# Rebuttal Proof of Evidence

**Land North of Possingham Farmhouse, Ashford, Great Chart, Kent**

**LPA Ref: 22/00571/AS**

**Appeal Ref: APP/E2205/W/24/3345454**

DRAWING TITLE:  
**SECONDARY ACCESS (GHOST ISLAND ARRANGEMENT INTO DEVELOPMENT ON THE A28)**

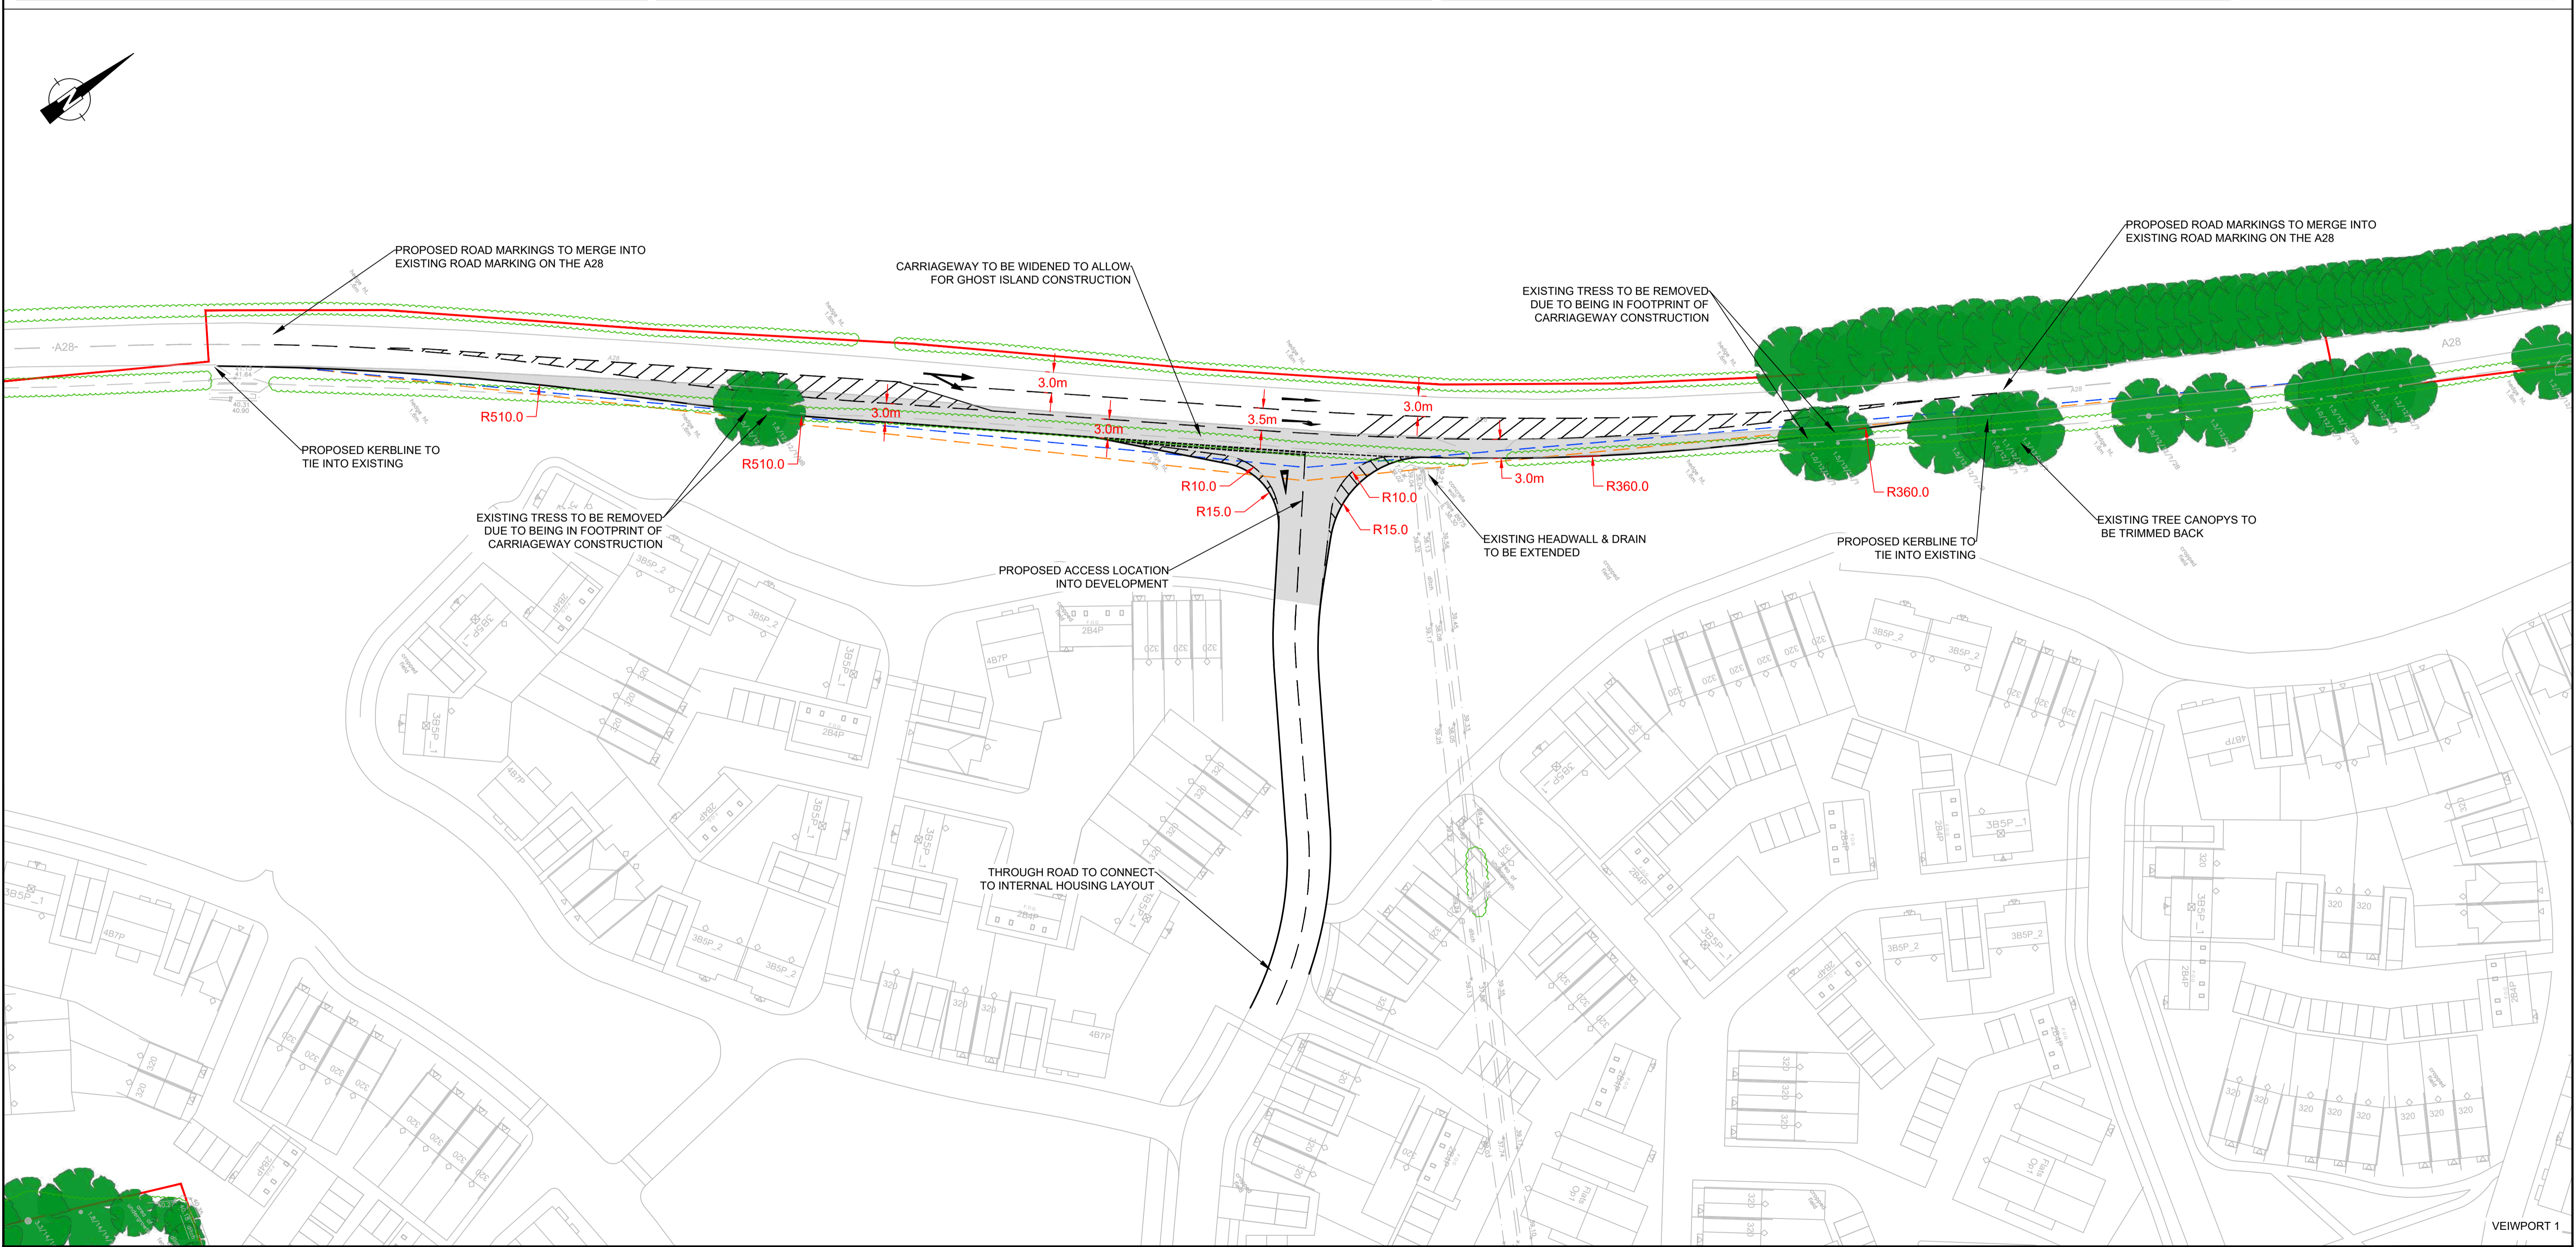
- 3.2 In paragraph 6.2 of his evidence, Mr Hogben states that a plan is needed showing the design of the secondary access including the revision to address the recommendation made in the Stage 1 Road Safety Audit. This has been prepared and is contained in **Appendix IDR1**. The minor amendment does not affect the capacity analysis undertaken. The provision of the secondary site access including this design revision can be secured through a suitably worded condition.

REV	DETAILS	DRAWN	CHECKED	DATE
A	MASTERPLAN UPDATED & RED LINE BOUNDARY ADDED	NL	SR	23.04.21
B	DRAWINGS UPDATED FOLLOWING RSA1 COMMENTS	NL	SR	13.09.24
